PROJECT BRIEF

Historic District Board of Review Application for Certificate of Appropriateness at 921 W. First St. build 22'x30' detached garage on block foundation w/ standard framing, 6/12 roof pitch, LP Smartsiding, 2 Sun windows, 2 fiberglass doors & steel overhead garage door; remove existing vinyl siding & install LP Smartsiding.

Application Date: June 5, 2023

HDBR Meeting Date: June 26, 2023

East Elevation

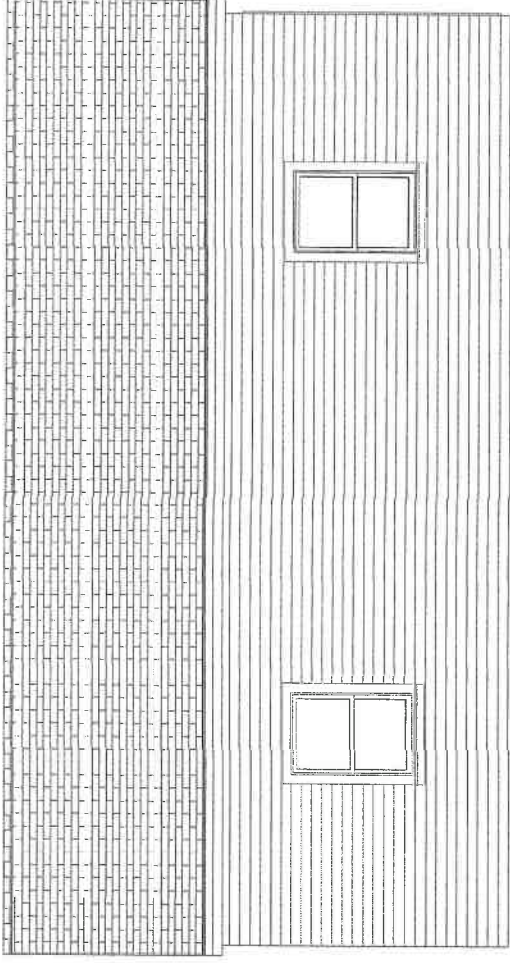
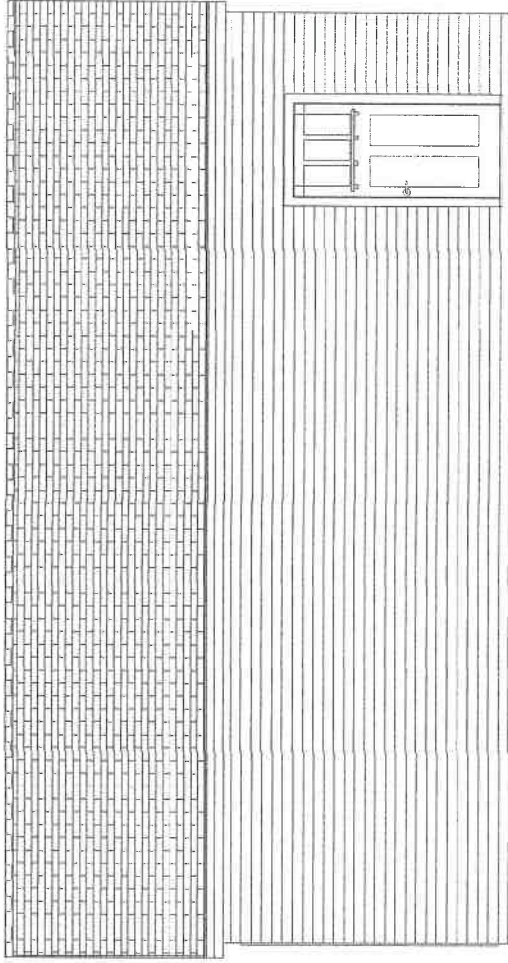
The project *is in* conformance with the Guideline 3.8-3.9 because the project will include replacing the existing inappropriate vinyl siding with more appropriate cementitious siding; *is in* conformance with Guideline 24.1 because the design of the proposed garage is in conformance with the Neo-Traditional style of the primary structure; *is in* conformance with 24.2 because the site plan indicates the location to be one compatible to the streetscape; *is in* conformance with Guideline 24.4 because the proposed garage will be of an appropriate mass, size, & height; *is in* conformance with Guidelines 24.5-24.8 because the proposed materials, windows, doors, and roof ridge/eaves will be compatible with the modern primary structure; *is in* conformance with Guideline 24.9 because the proposed garage will have two separate doors for each car bay; *is in* conformance with the Ordinance because the proposed garage is compatible with the rhythm of spacing of buildings on the alley behind W. First.
